Suggested location for Inspector's site visit – The British Horse Society

Pertenhall BW 26 and Bolnhurst & Keysoe BW 37 (APP-121 Masterplan sheets d and c, APP-010 Streetworks plan sheets 1, 2 and 3, APP-160 Outline PROW mgmt plan and APP-070 Visual Receptors Figure 5-4a)

There are two pinch points where we do not consider there is enough space to achieve safe segregation. We ask that the Inspector looks carefully at both these points – shown as A and B on this extract from APP-010 sheet 1:

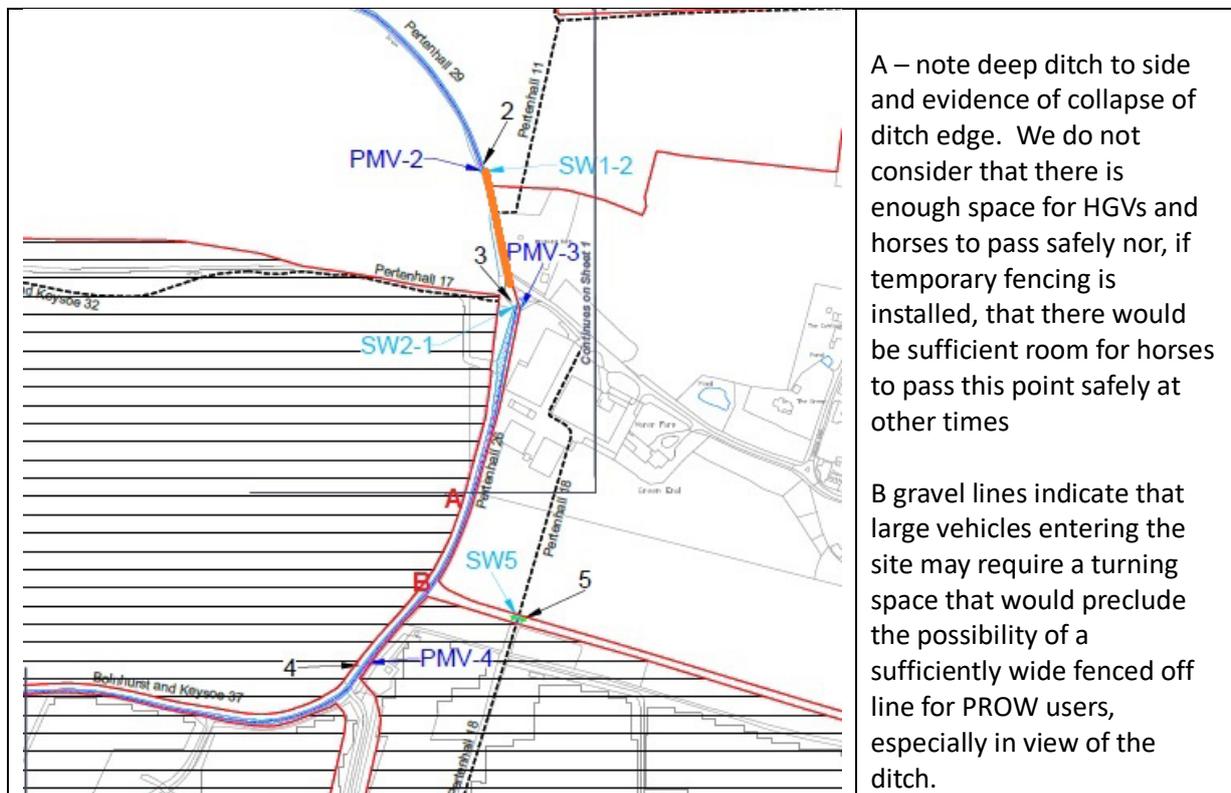
In Manor Farm farmyard, the bridleway will be shared with construction traffic. The oPROWMP (section 6.4) notes that, during construction, bridleway users continue to use the existing bridleway track and verges but that “temporary fencing could be used segregate them from construction traffic”.

We ask that the Inspector then looks on the other side of the hedge behind the ditch to see that an alternative, safer headland route can be provided (albeit on land outside the red line but in the ownership of Manor Farm).
